**Re: EB-2011-0063 – Grand Renewable Wind, LP (the “Applicant”)
Final customer impact assessment (“CIA”) and system impact assessment (“SIA”)**

GRAND RENEWABLE ENERGY PARK PROJECT

Final Report

CAA ID 2010-399

Figure 1: Proposed Connection Arrangement

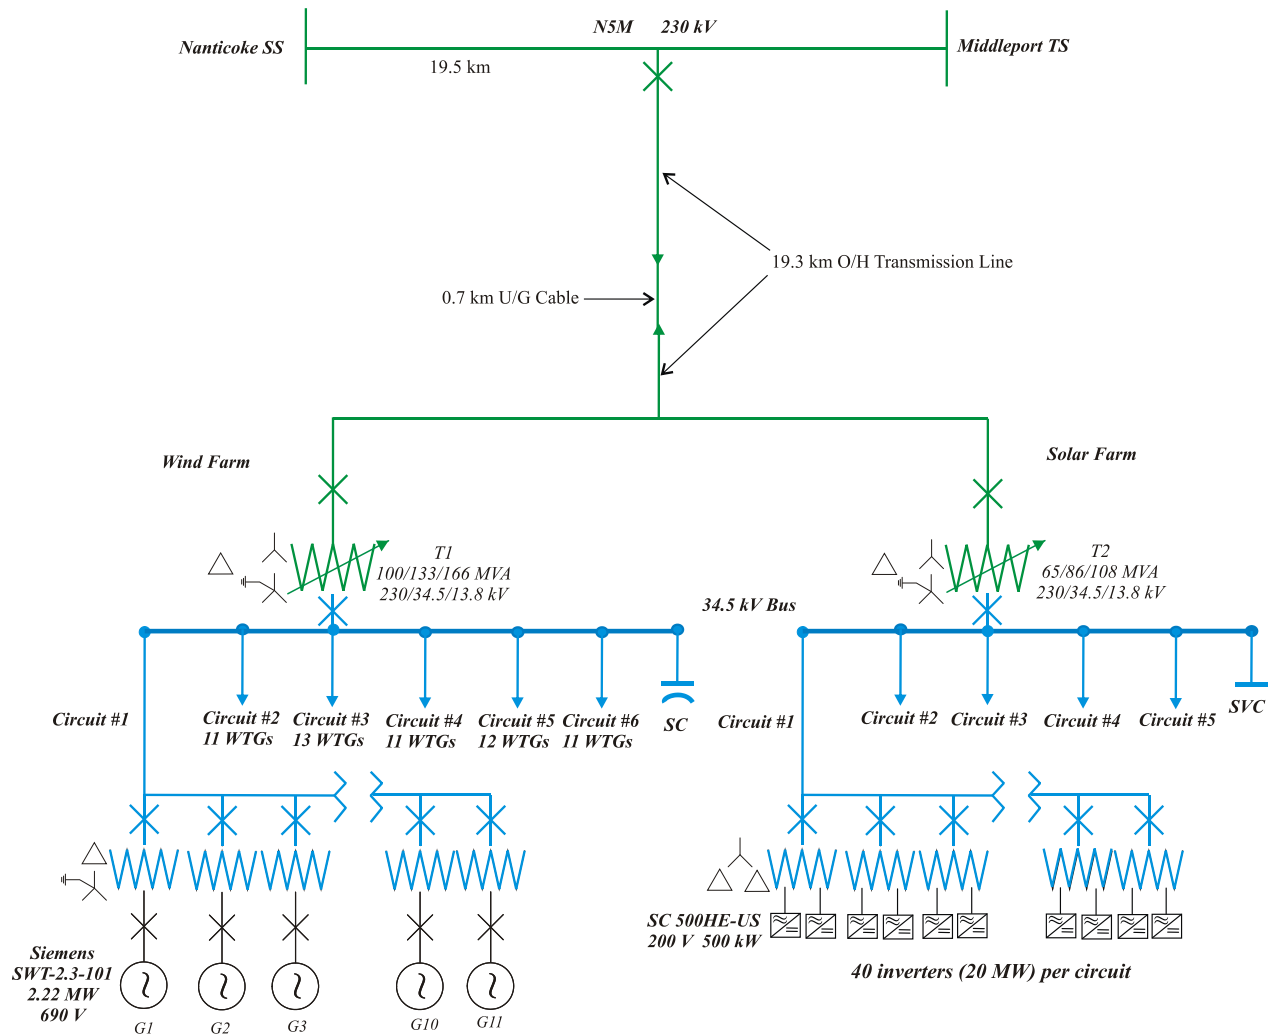
The initial proposed main step-up transformer configuration was Y-grounded/Y-grounded/Delta as shown in Figure 1. Based on the study results from the Protection Impact Assessment it is required to leave the HV winding ungrounded. This will be discussed in Chapter 4.

- (2) The applicant is required to provide a copy of the functionalities of the Wind Farm Management System (WFMS) to the IESO.
- (3) Based on the Protection Impact Assessment performed by Hydro One, to overcome relaying difficulties, both the wind generation and solar generation step-up transformers are required to have the primary windings (high voltage) ungrounded. The proponent agreed that the transformers configuration will be Y/y-grounded/delta for the 230/34.5/13.8 kV transformers.

Figure 7: Terminal Voltage of Wind Generator during LLLG Faults at Nanticoke SS

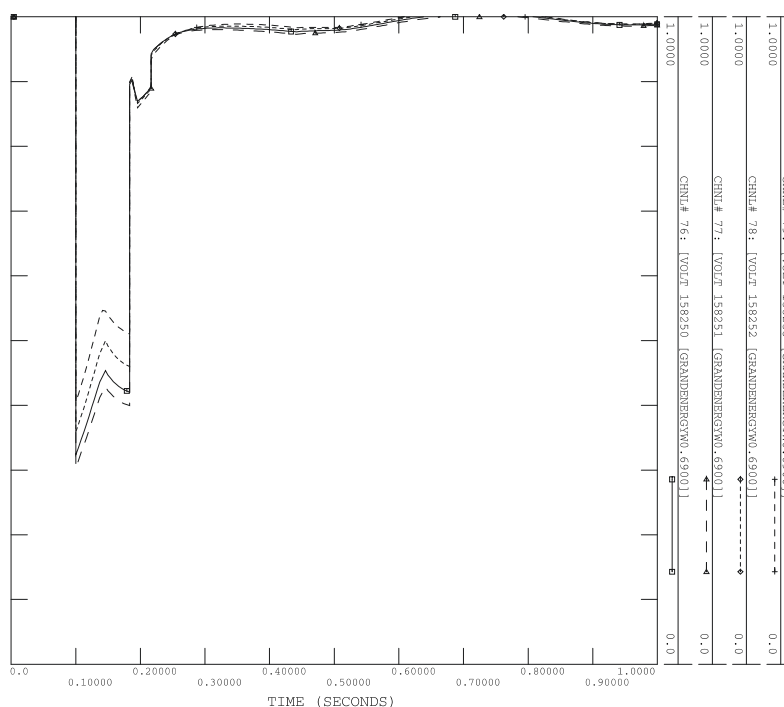
The variation of the terminal voltage of the new generation facility is plotted in Figure 7 below. It can be seen that the duration during which the generator terminal voltage drops below 0.3 pu is about 0.116 sec. Therefore, the fault ride through capabilities of the wind turbines and PV inverters are adequate.

The LVRT capability must be demonstrated during commissioning by monitoring several variables under a set of IESO specified field tests and the results should be verifiable using the PSS/E model.

Figure 1: Samsung Grand Renewable Energy Park Connection to HONI Transmission System.

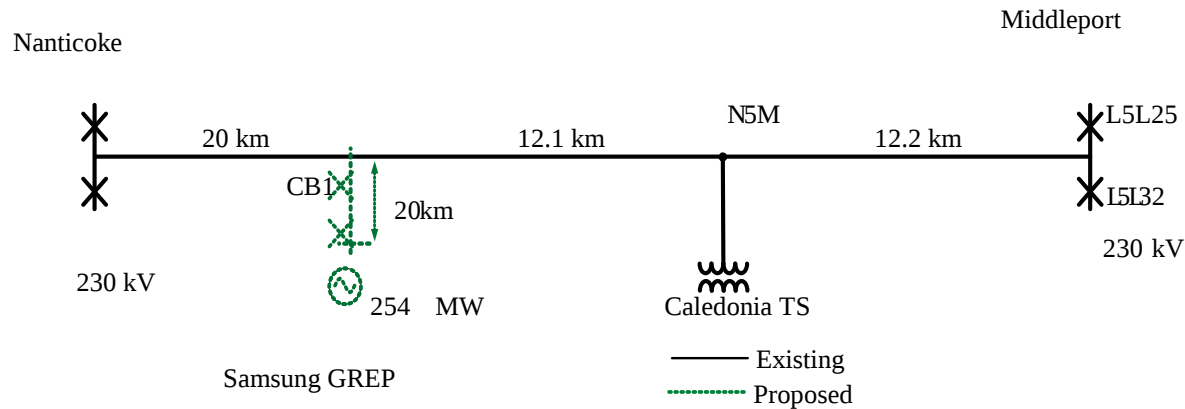
It is feasible for Samsung Grand Renewable Energy Park to connect the proposed 154 MW and 100 MW generation to circuit N5M at the location as shown in Figure 1 as long as the proposed changes are made:

Protection Setting changes will be required.
